LASER INTERFEROMETER GRAVITATIONAL WAVE OBSERVATORY

LIGO-T1200551-v2

## Optical-lever installation interferences at LHO

**Figure 1: HAM3 Oplev transceiver as installed by WAMCA1, looking into VP7.**

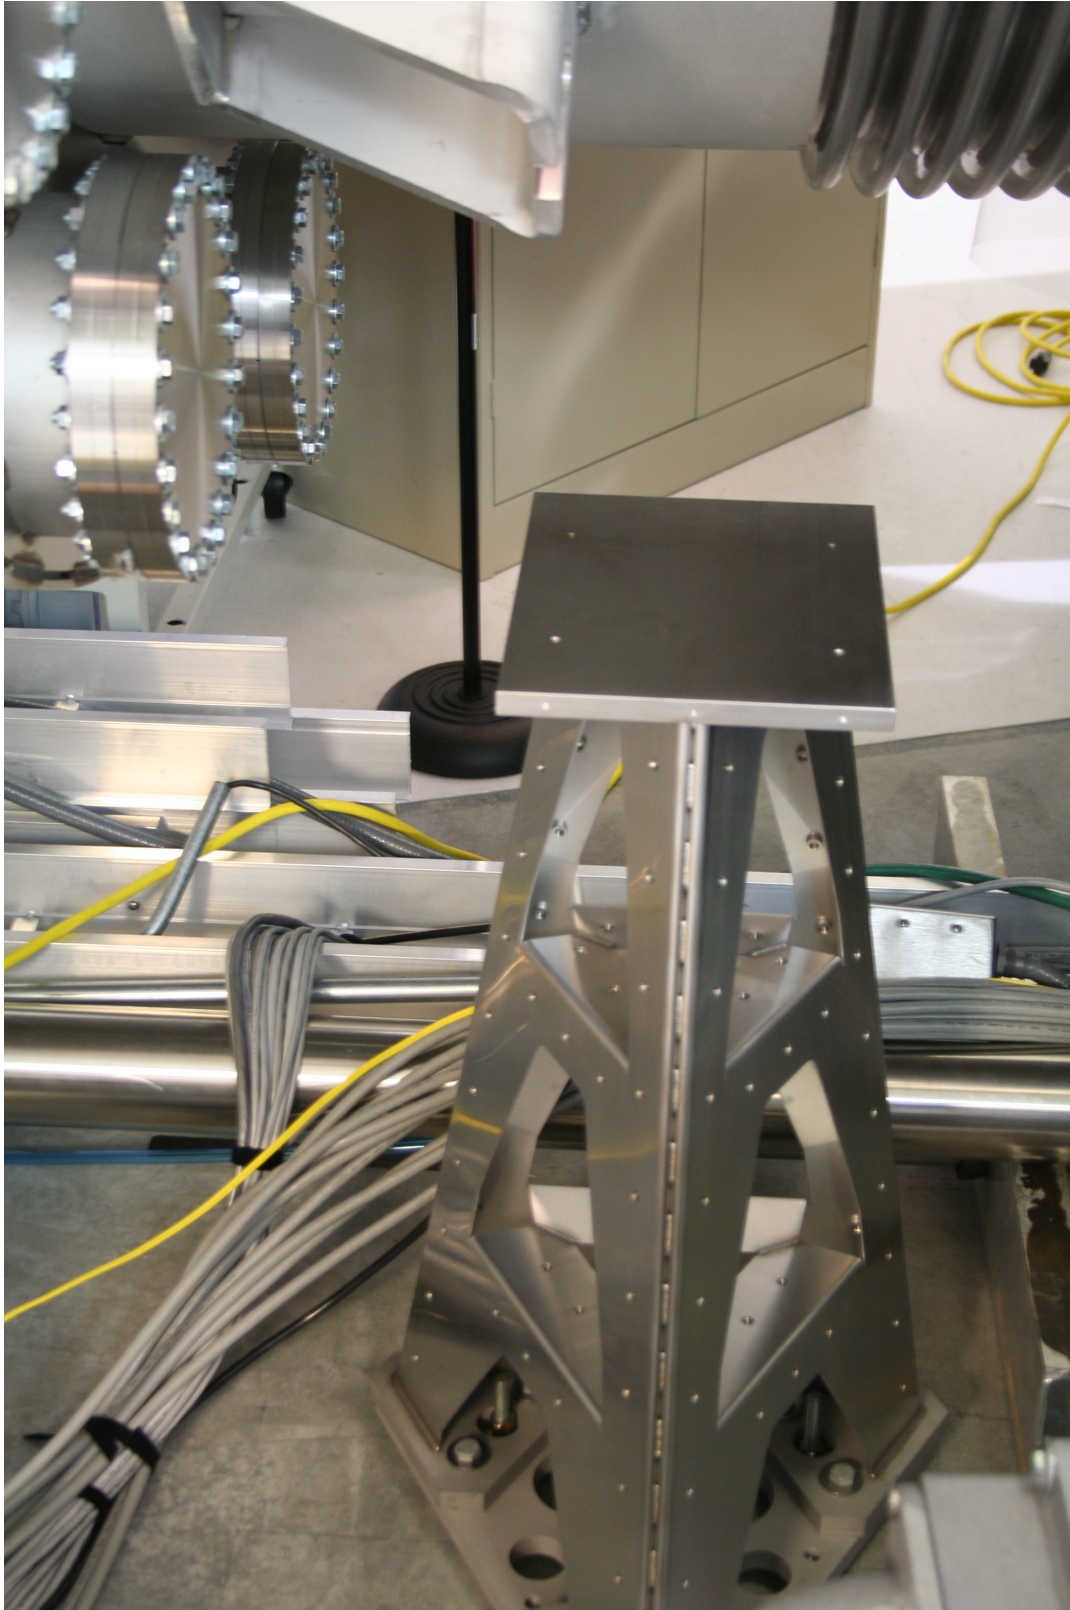
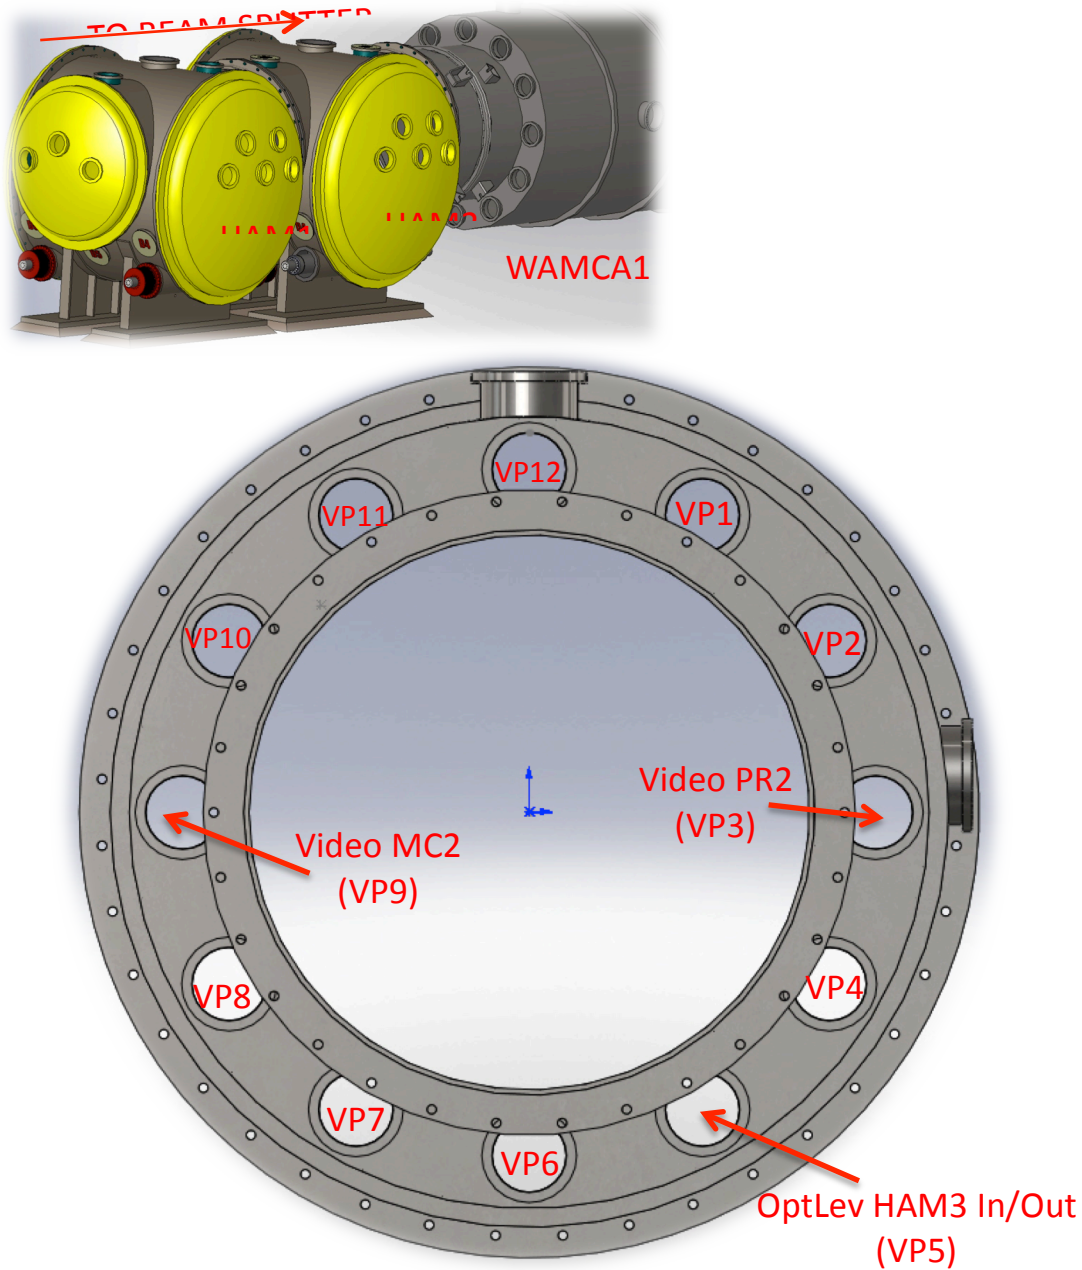
Notes: This transceiver was installed on the wrong side of the beam tube. It faces viewport VP7 whereas the design called for it to look into VP5. There is no interference with the pylon in this incorrect spot, but there is in the correct location.

Recommendation: As long as there is no interference inside the vacuum chamber, leave it the way it is. The reflecting mirror on the HAM table will have to be rotated laterally (in yaw) by about four degrees to return the beam, but since this mirror sits on the near edge of the table this should not be a problem. It is my understanding that there is a hole in the beam-tube baffle that would allow the oplev beam to come in and out of VP7.

**Figure 3: PR3 transmitter-pylon floorplate footprint, bounded by yellow tape in the foreground.**

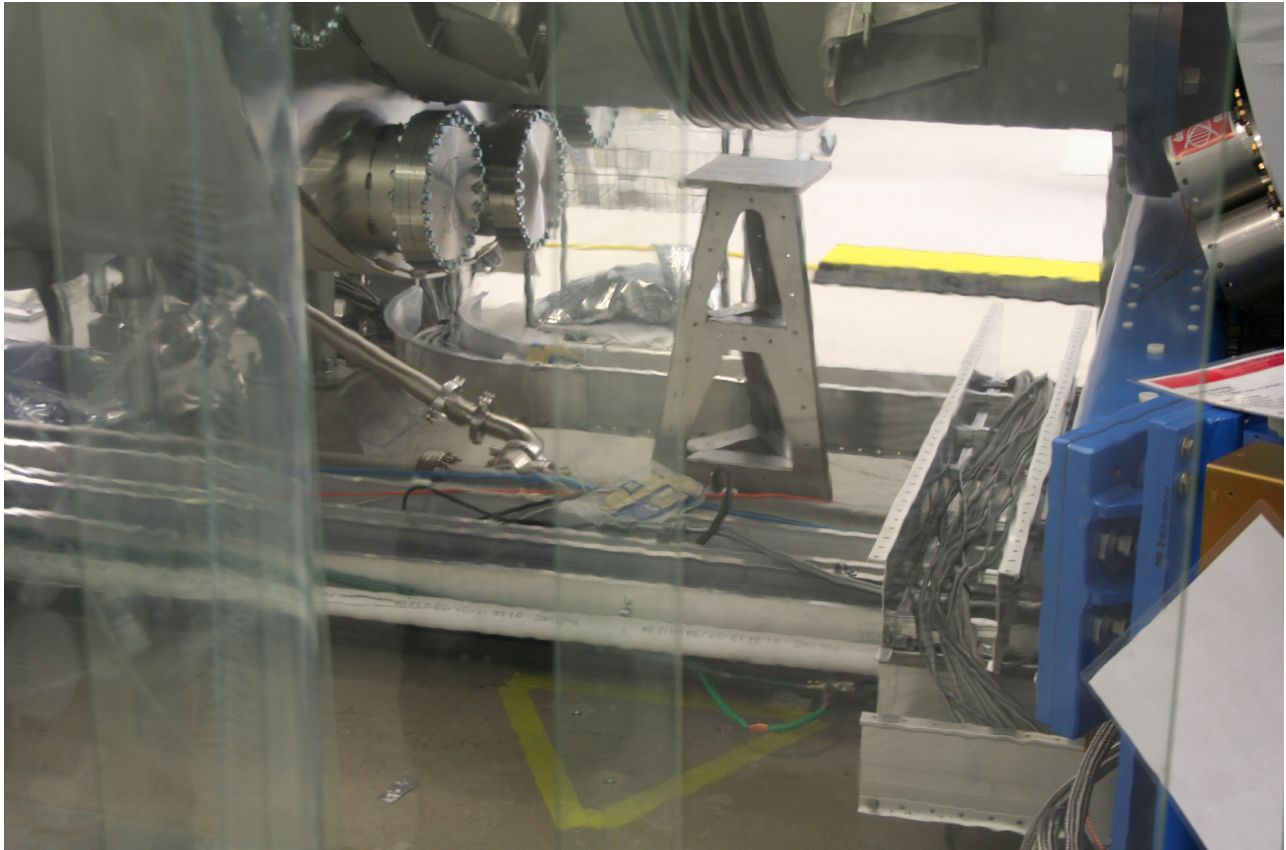
Notes: Only one piece of pvc pipe is in the way here. The holes have been drilled in the wrong orientation, according to the floor-occupancy diagram. According to G1000740, the triangle should point into the beam-tube axis, and as shown in the photo below, it is now pointing out. This would be the correct orientation for LLO, according to G1000700, and may be just fine for LHO.

Recommendation: Re-route or remove pvc pipe. Leave orientation the way it is. UPDATE 1/30/13: John Worden and I pushed the pvc pipe out of the way and installed this pylon. As long as Richard McCarthy signs off on the close contact with the cable tray, we're done here.

**Figure 5: Viewport locations for HAM5 and SR3 oplevs, taken from Figure 40 of T1000746, Viewport Final Design. The photo in Figure 4 views this flange from the right.**

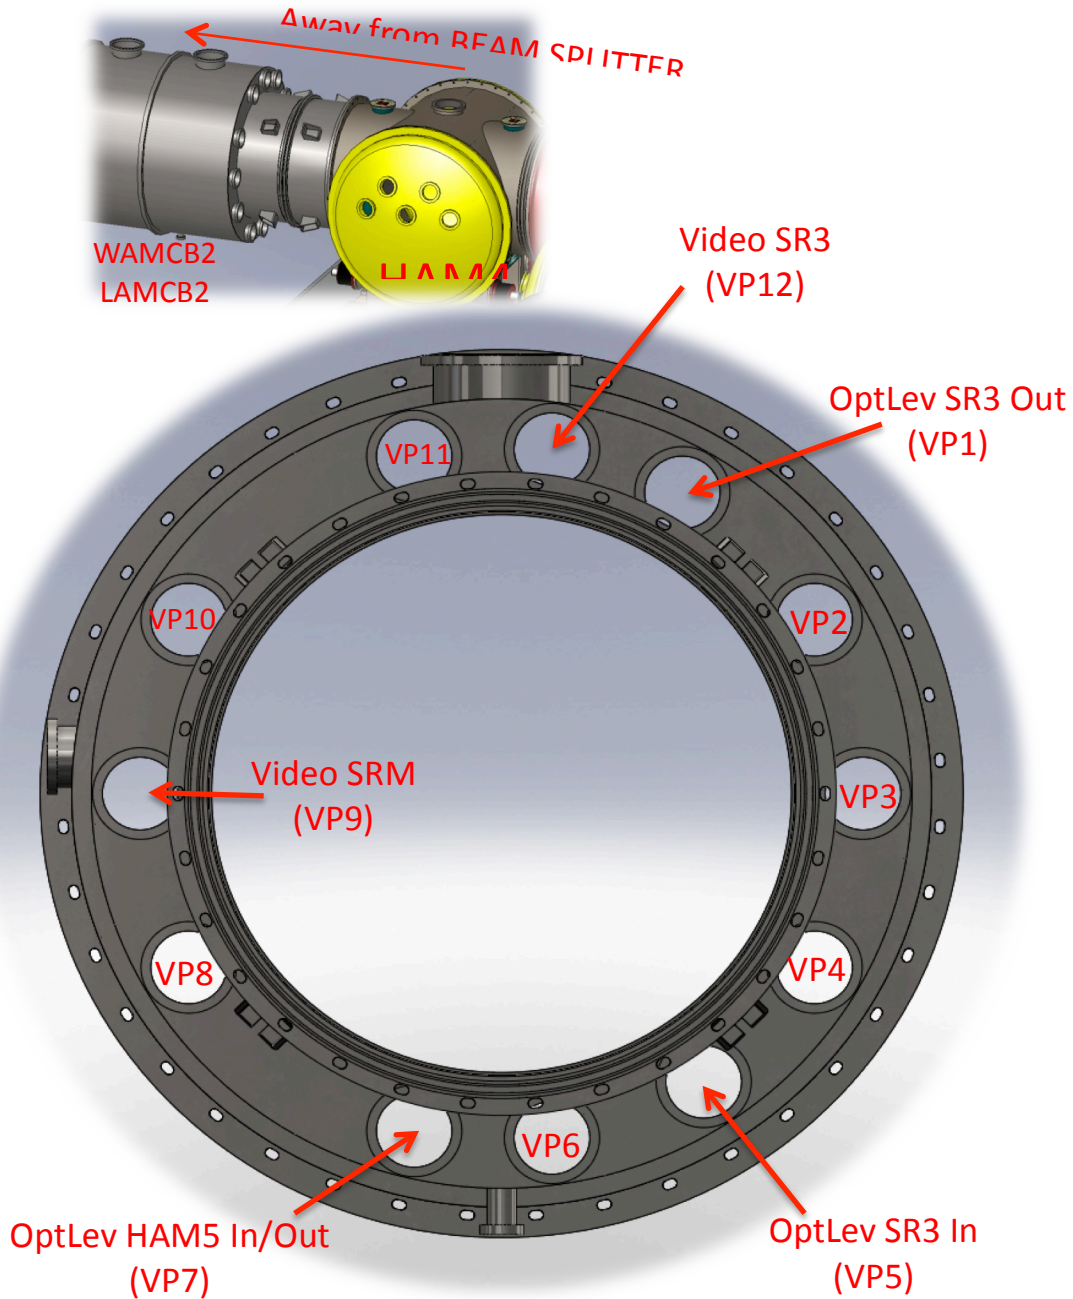
Notes: Significant interference. See photo. As of this writing, we are measuring to see if we can get away with just moving the cable trays, or if we need to move pipes as well. Even if we don't need to move pipes for this one, they will almost certainly need to be moved for the HAM5 transceiver.

Type: HAM Transceiver  
 Location: Under HAM4, looking into VP7 of WAMCB2  
 Notes: Significant interference. See Figures 4 and 5.

Recommendation: Re-route purge-air pipe. Re-route cable tray.

Recommendation: Trim pylon so that vacuum foreline can pass through. *Note: Modeling should be performed and verified before installation, drilling, or cutting is done.*

**Figure 6: ITMX location, from the opposite side of the beam tube from the transmitter. The dwarf is supposed to sit next to the red TCS table. There are lots of pipes in the way.**

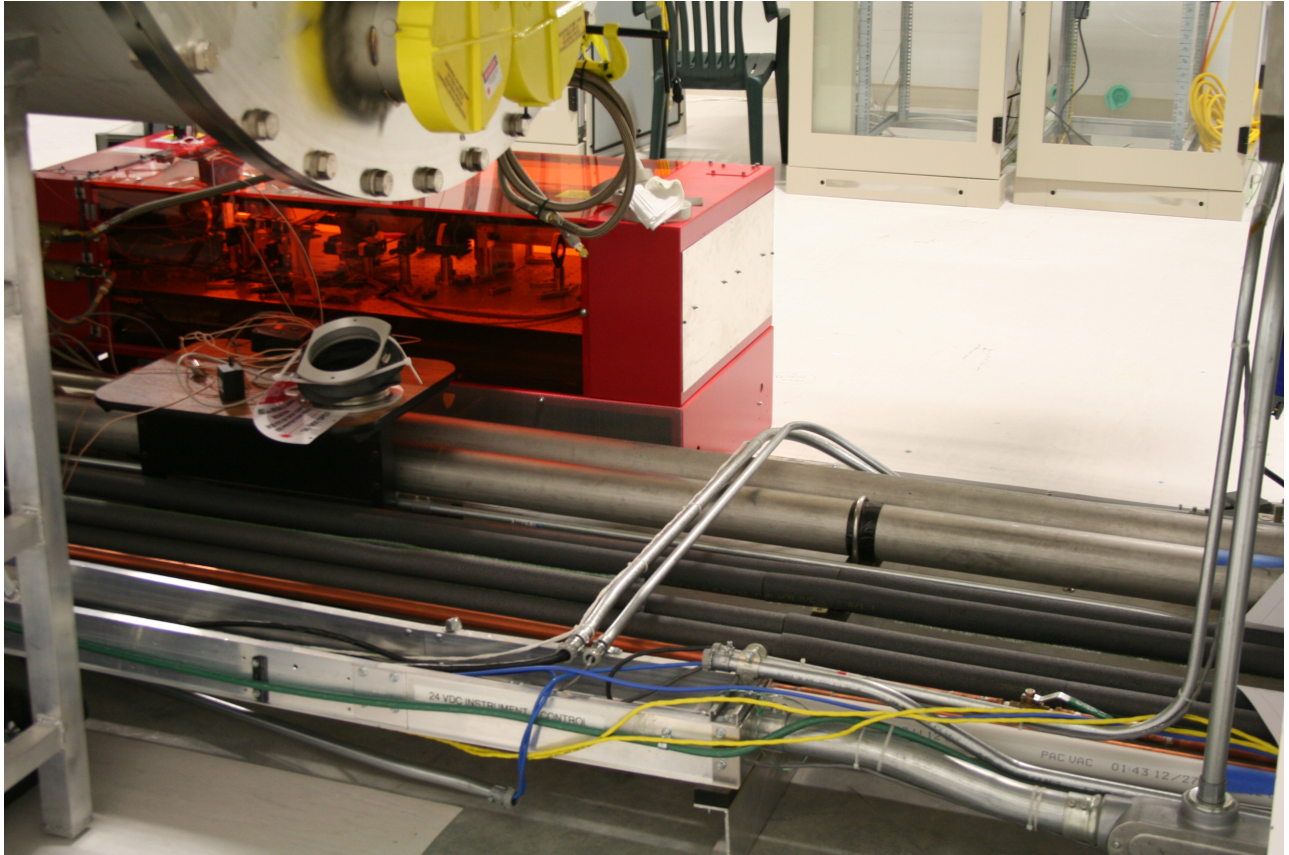
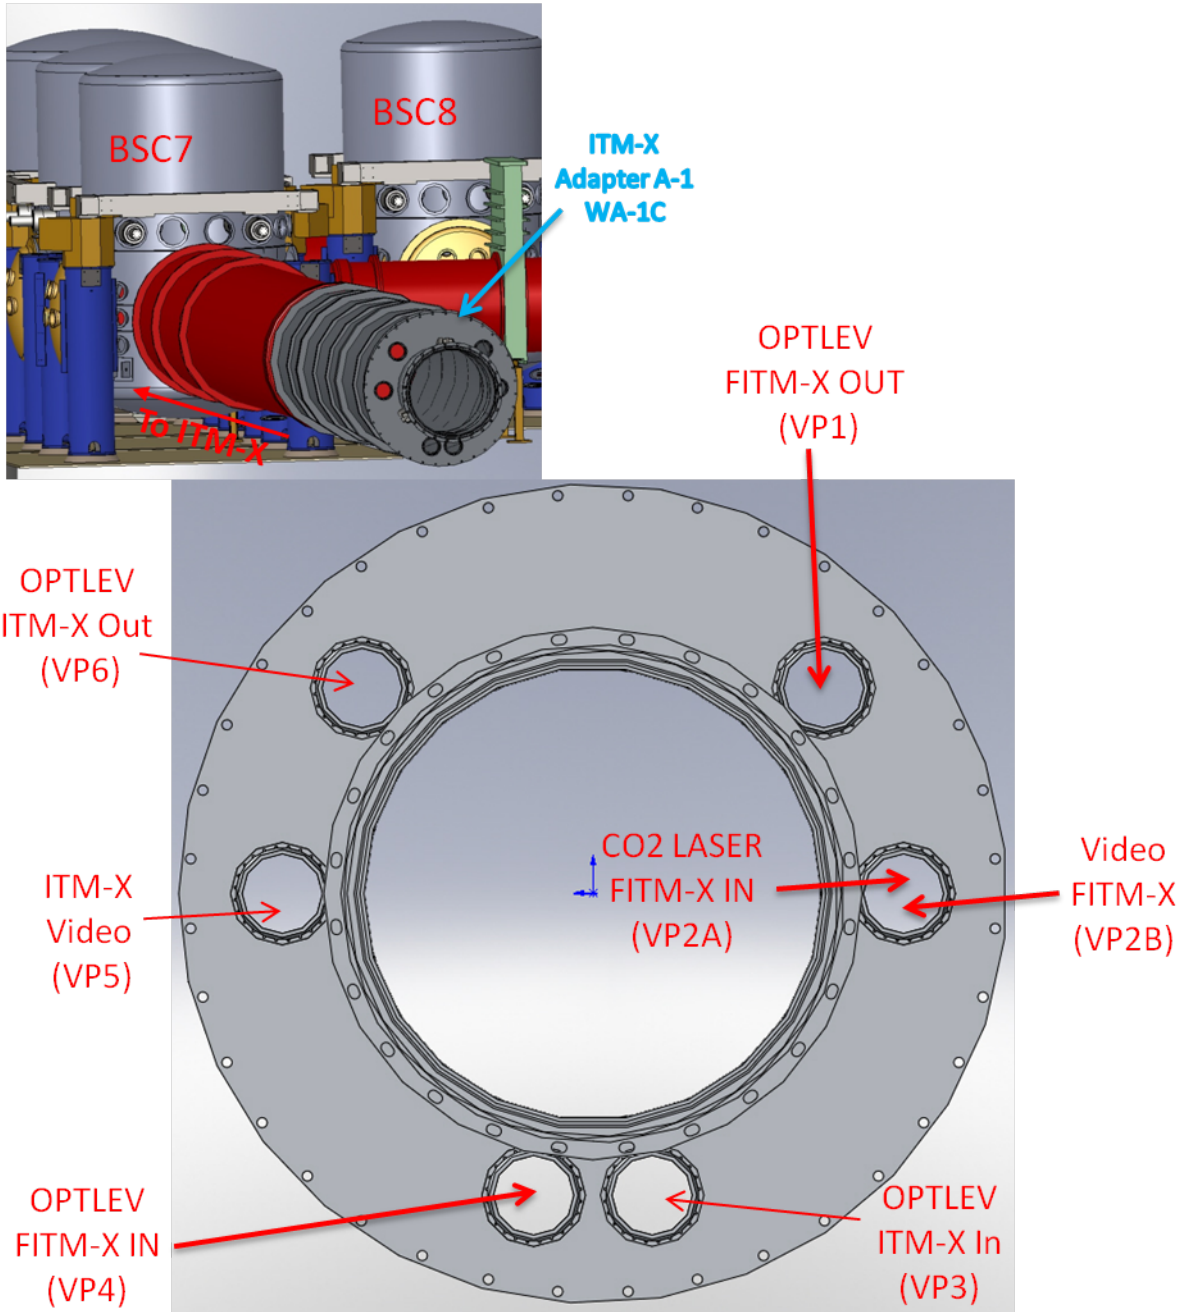
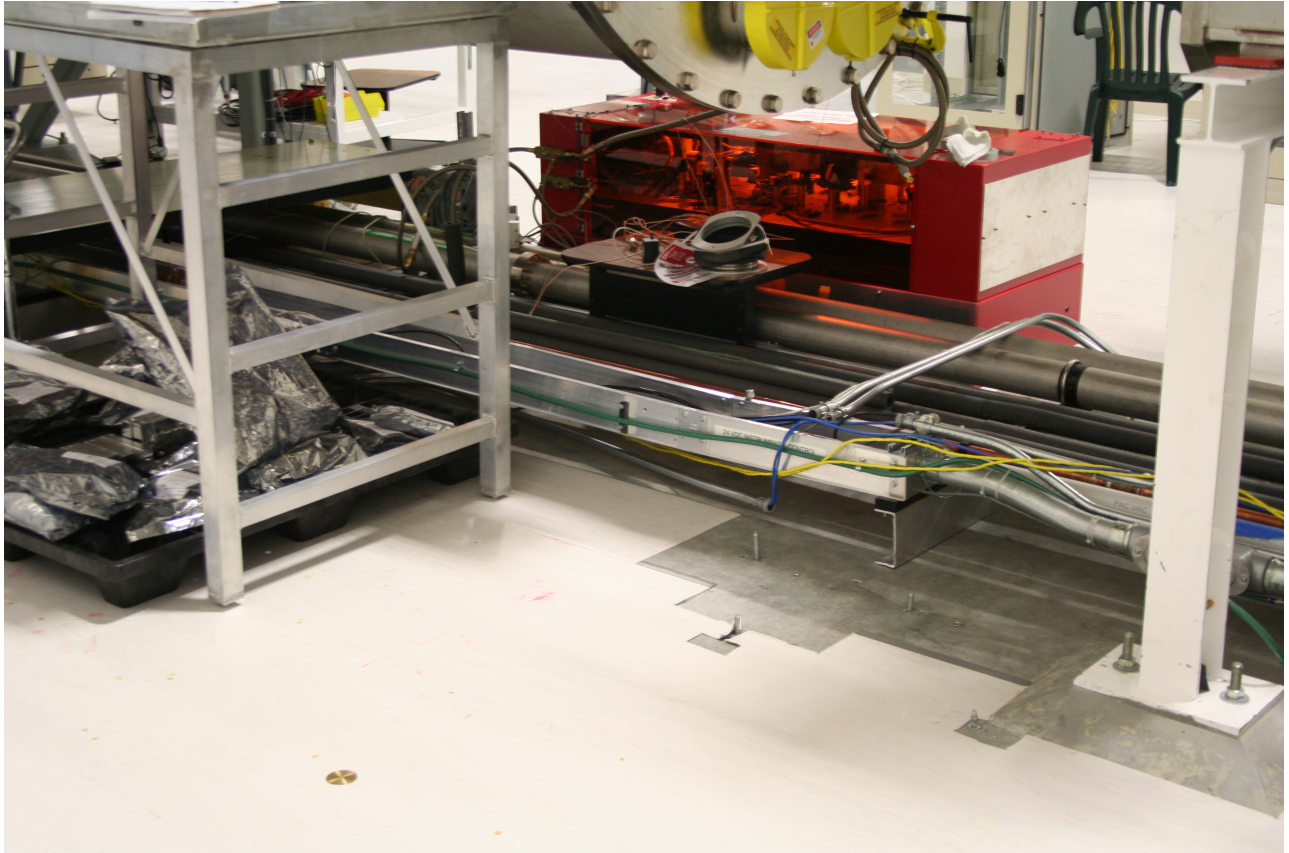
Notes: Significant interference. See figures below.

Recommendation: Re-route or remove interfering pipes. Mount initial-alignment monument LV7 on leaner’s baseplate. Translate leaner parallel to beam axis as needed.
